Comment Response Summary

PixID GSA Public Review Draft Groundwater Sustainability Plan dated October 27, 2019

Figure A1-8 from the Tule Subbasin Monitoring Plan (Attachment 1 of the TSCA)

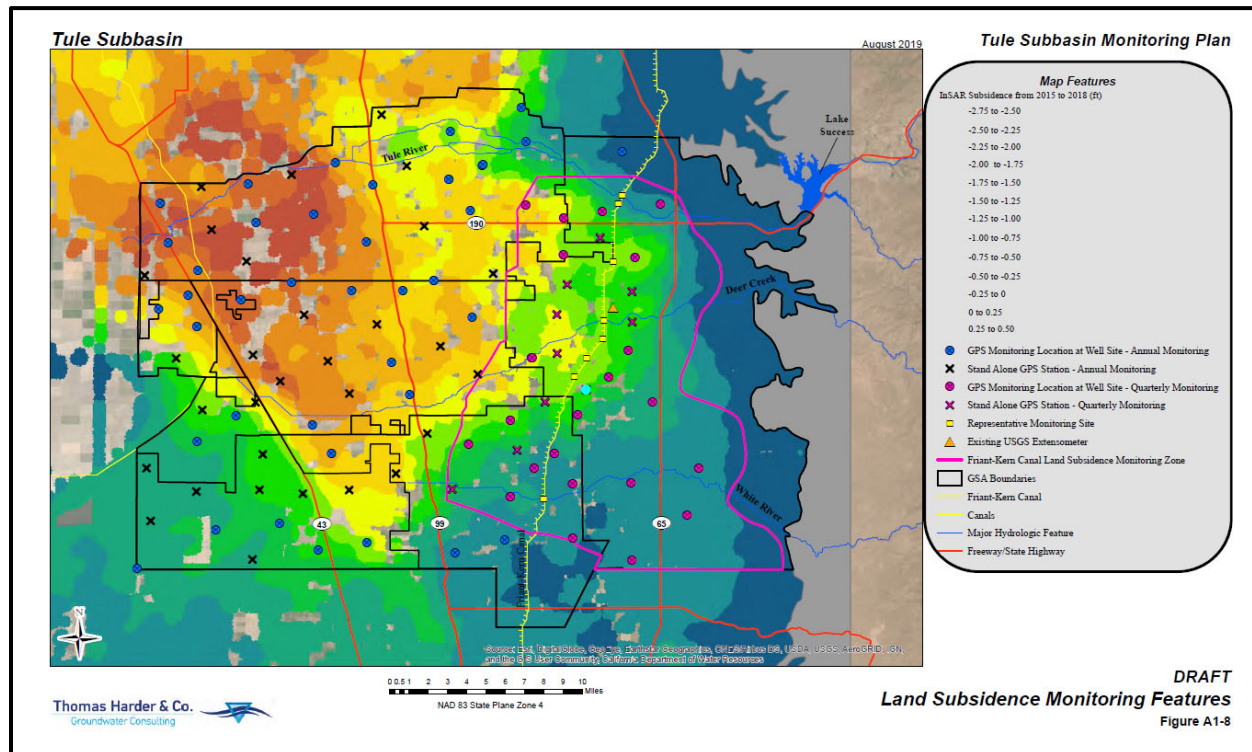
The Tule Subbasin contains a “land subsidence monitoring area” that is approximately centered around the FKC and extends west four miles and eastward to the 1-ft cumulative subsidence 1986-2017 contour. This area is shown by the solid pink line in Figure A1-8 of Attachment 1 of the TSCA (see figure below). This map figure also shows the cumulative subsidence between 2015 and 2018 based on InSAR data. Based on this data, the subsidence along the FKC during this period was up to 1.25 ft.

The ETGSA contains a “Friant-Kern Canal Subsidence Management Area” which appears to be the same as the “land subsidence monitoring area” mentioned in the TSCA Monitoring Plan.

Figure 6-3 from the ETGSA GSP

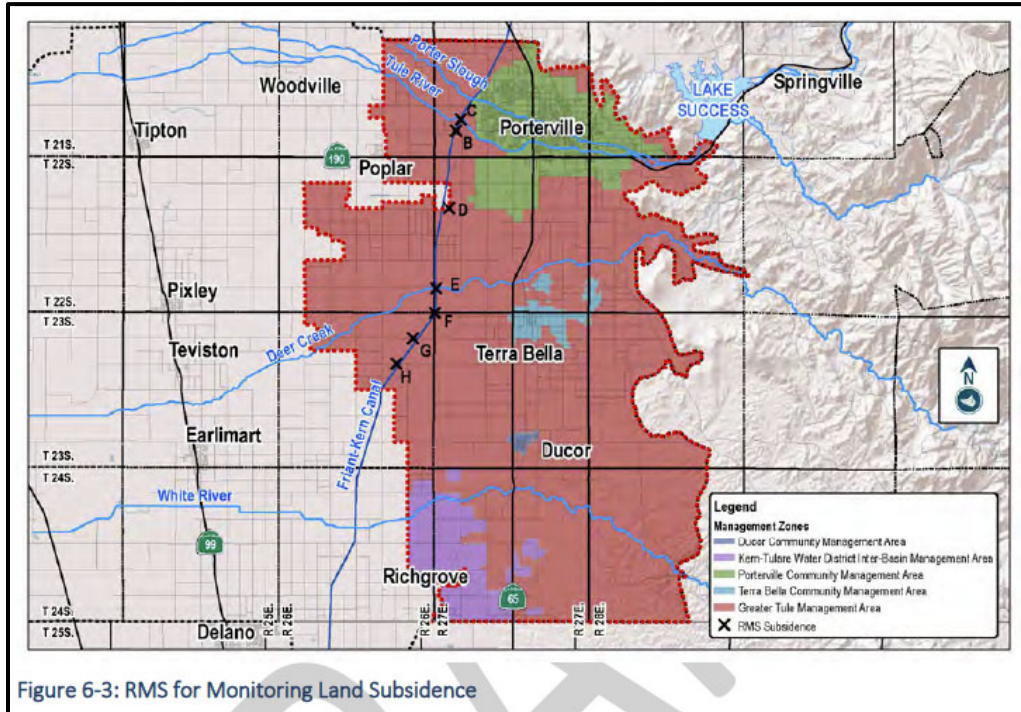
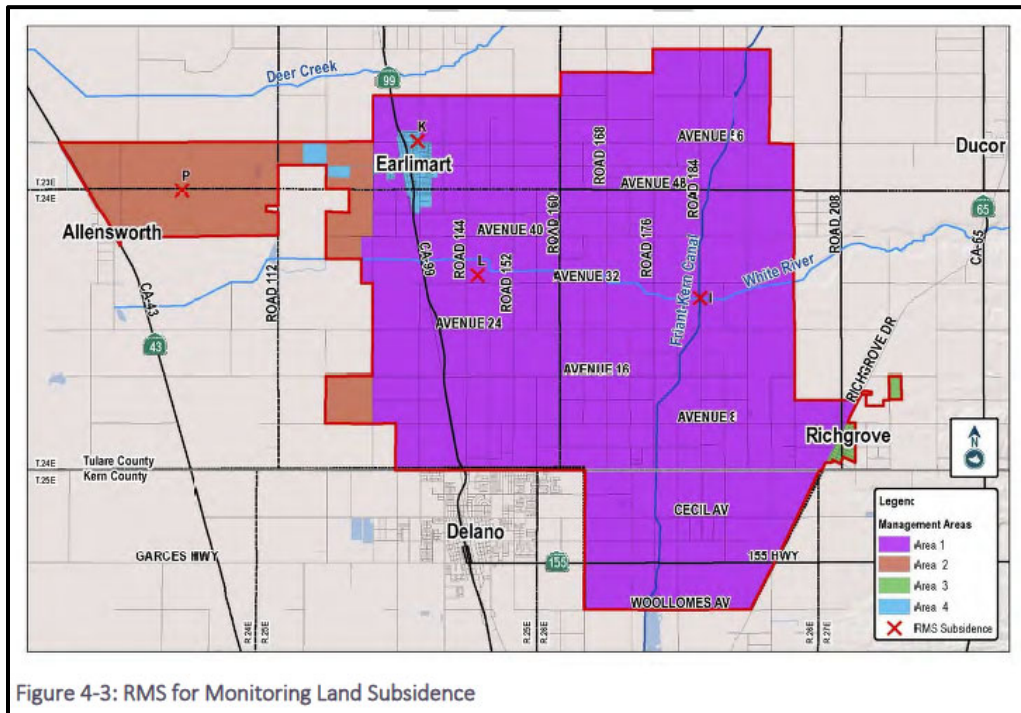
Comment: The Monitoring Network for subsidence in the vicinity of the FKC is inadequate.

**Figure 1 - Representative Monitoring Network for GW Levels Relative to Domestic Wells, DACs, and Community Water Systems
Pixley Irrigation District GSA**

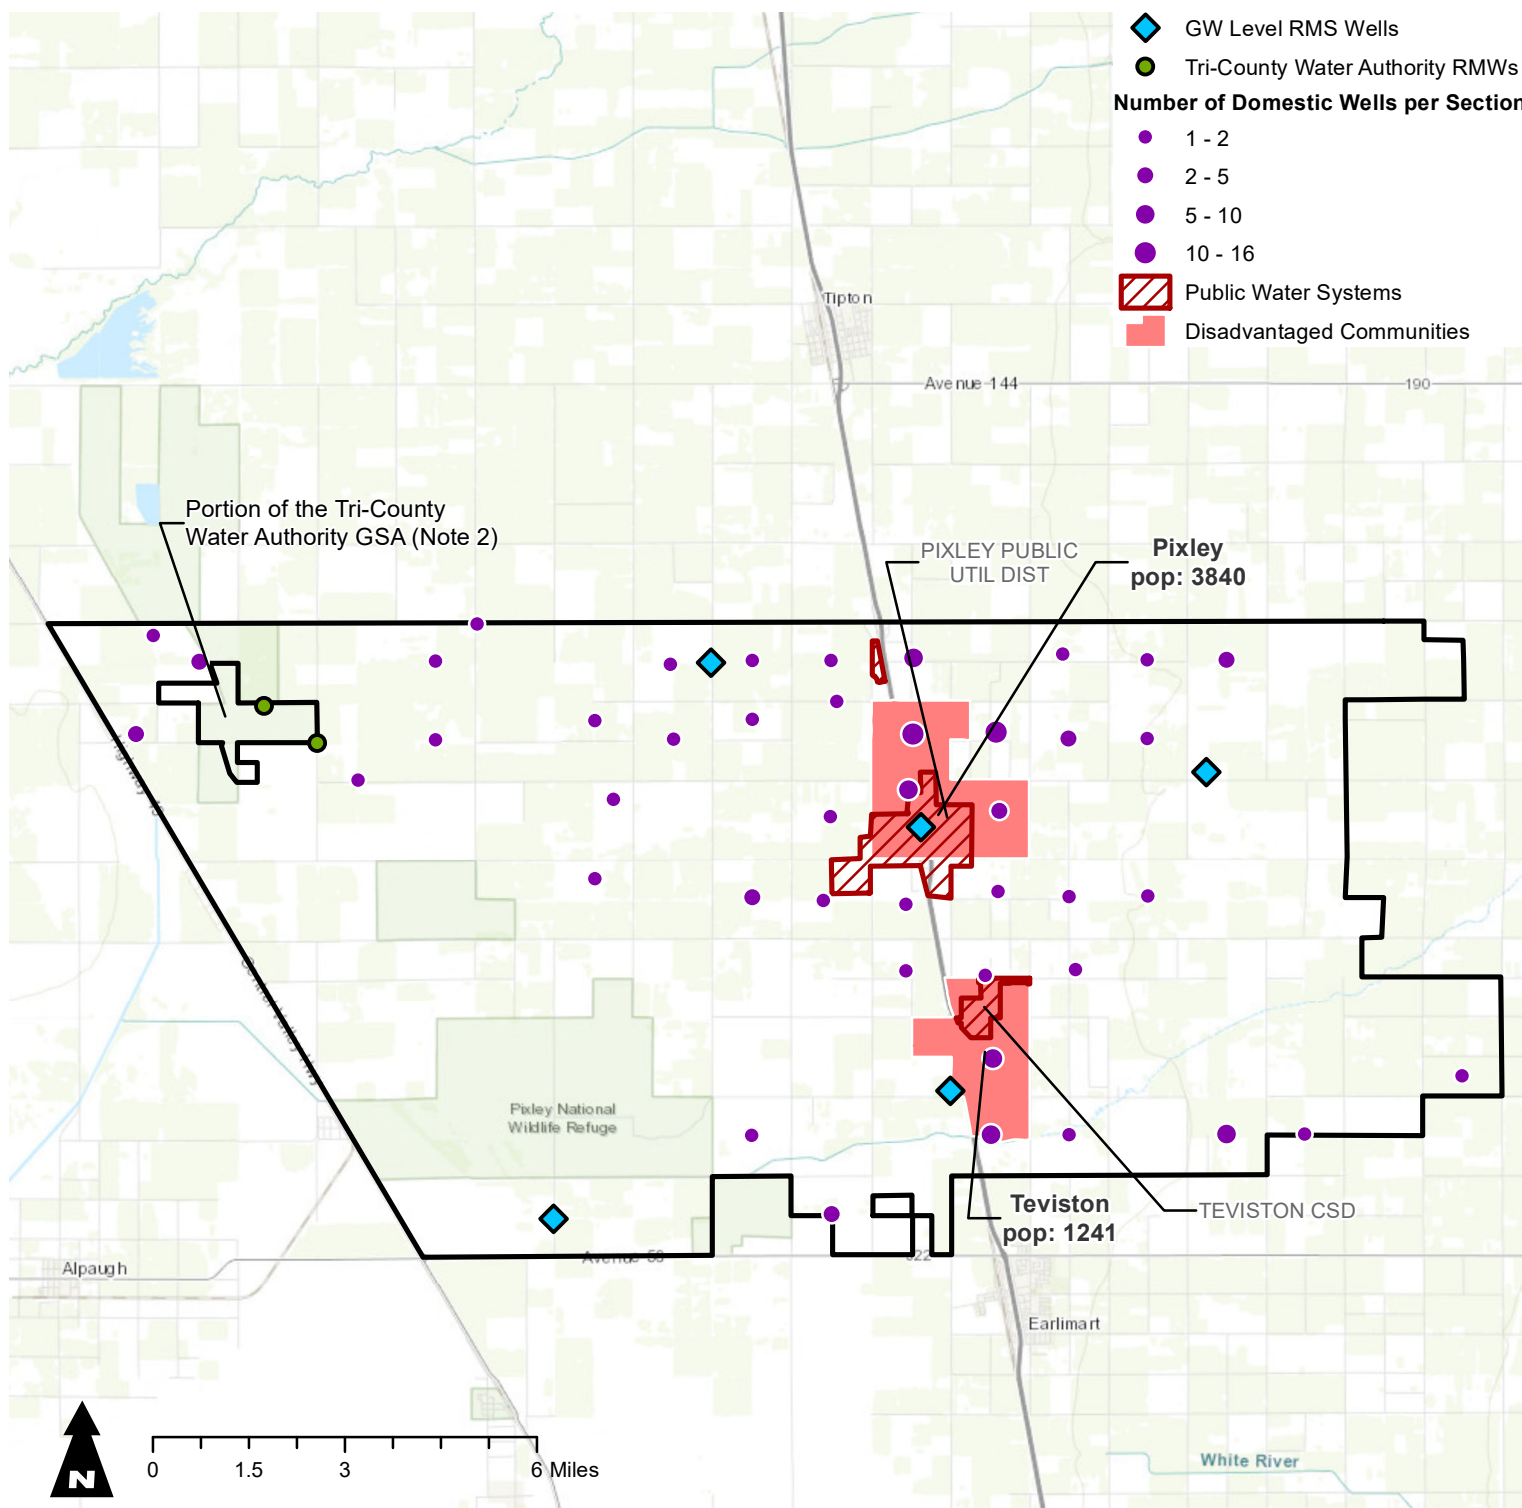
4. Information of the Representative Monitoring Site for groundwater level in the draft GSP is conflicting. RMS wells are located by combining information from Figure 2-34, Table 1A-1, and Table 1A-3 in draft Tule Subbasin Monitoring Plan, dated August 2019. The MOs and MTs are from Table 3-2 and Table 3-7 in the draft Pixley Irrigation GSA GSP - Public Review Draft dated September 2019.

Figure 4 - Representative Monitoring Network for GW Quality Relative to Domestic Wells, DACs, and Community Water Systems
Pixley Irrigation District GSA

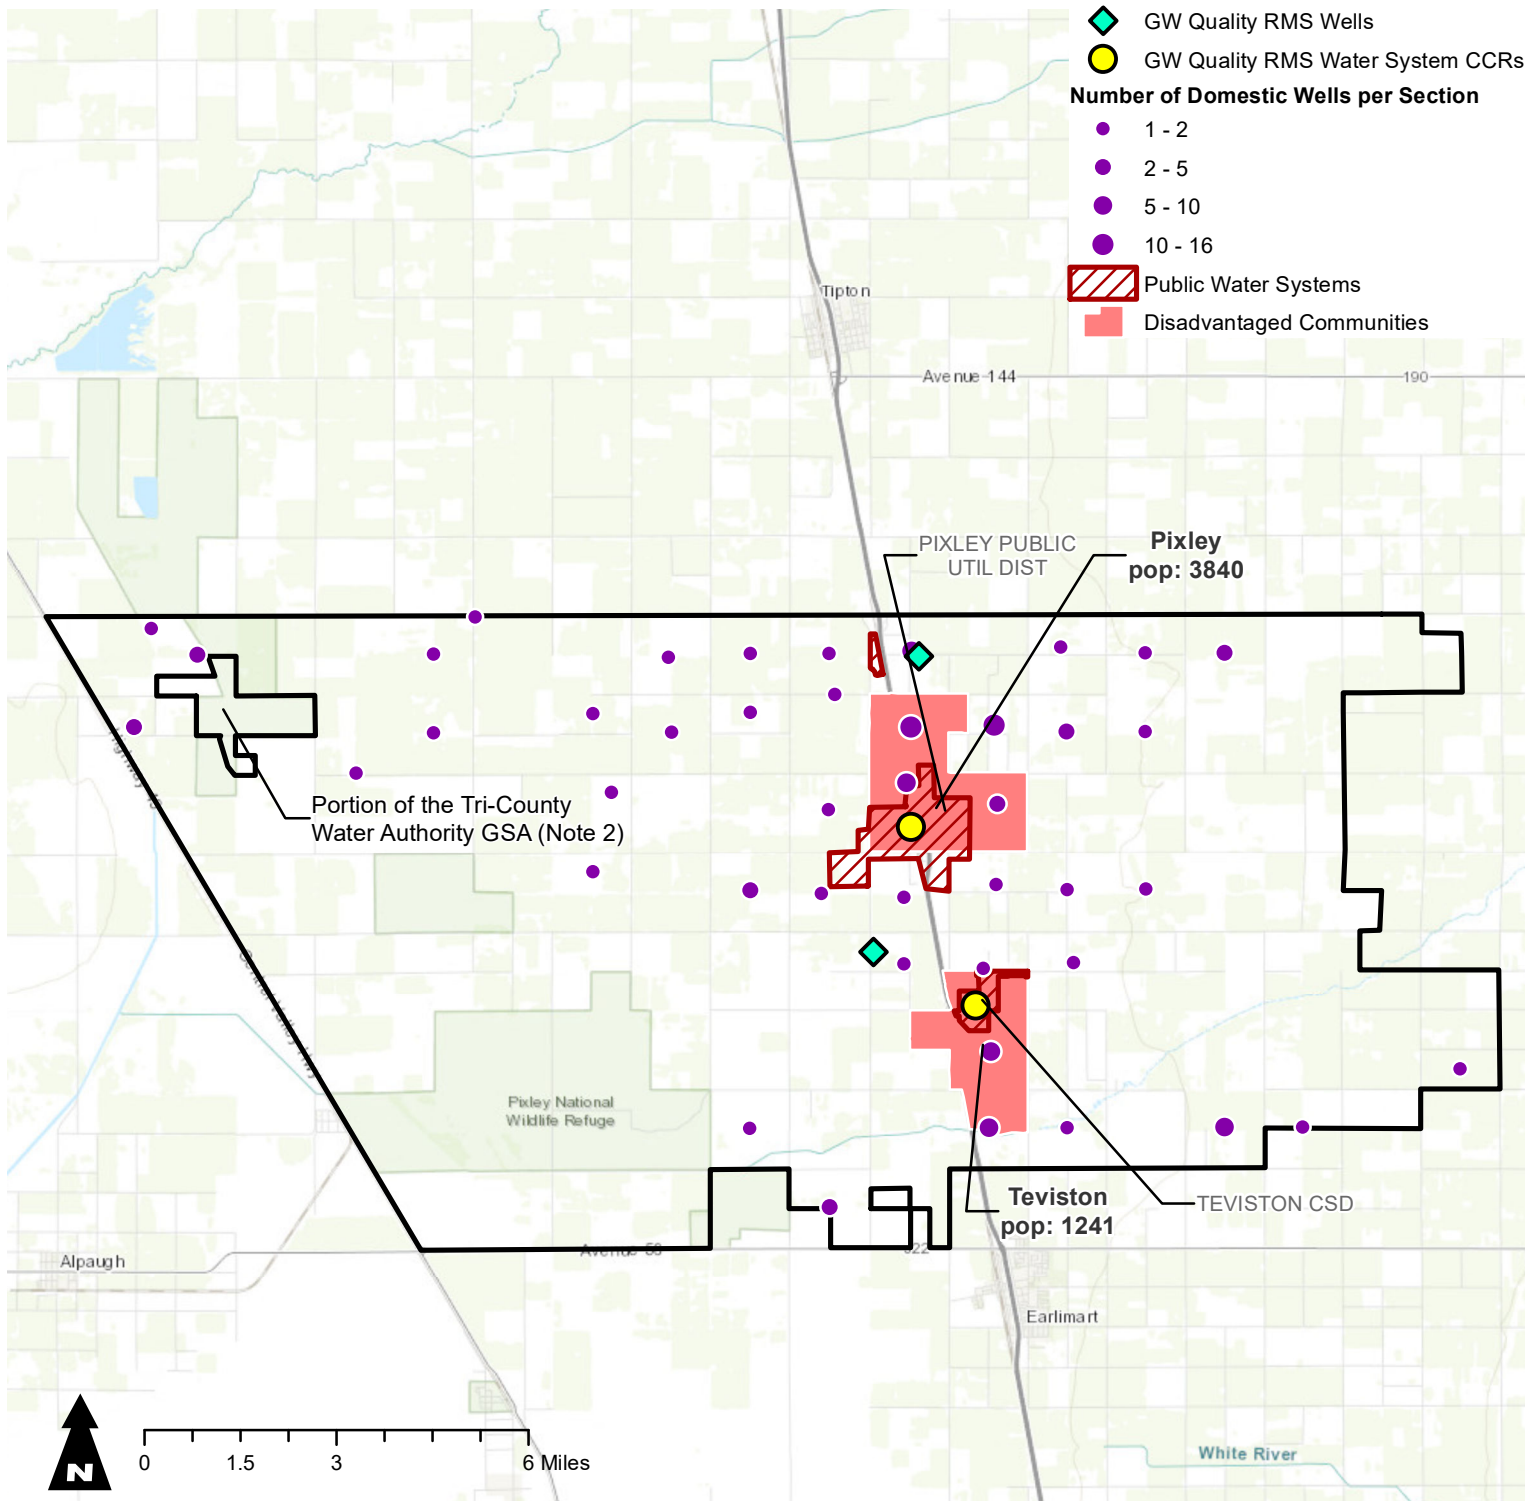
- E.45** • **Evaluate and demonstrate how the proposed water quality monitoring network is sufficient to monitor for impacts to domestic well users in the PID GSA area and expand the monitoring network to address these gaps.** CWC Figure 4 shows the locations of the water quality RMS (based on draft GSP Table 4-2), DACs, public water systems, and domestic wells in the PID GSA. The RMS are generally located near DACs and community water systems, but provide minimal coverage for the domestic well users that are well distributed across the northern portions of the PID GSA area. The proposed network of water quality and water level RMWs appear to be insufficient to monitor impacts to groundwater for drinking water beneficial users, particularly domestic well users. Without adequate monitoring that capture shallow aquifer impacts for both levels and quality, domestic well users may be vulnerable to lack of access to safe water. This monitoring is required by 23 CCR § 354.34 therefore, PID GSA should develop plans to fill the data gaps for these sensitive communities and specify where the location of these new RMW will be located and if they will be used for groundwater level or quality MTs/MOs.
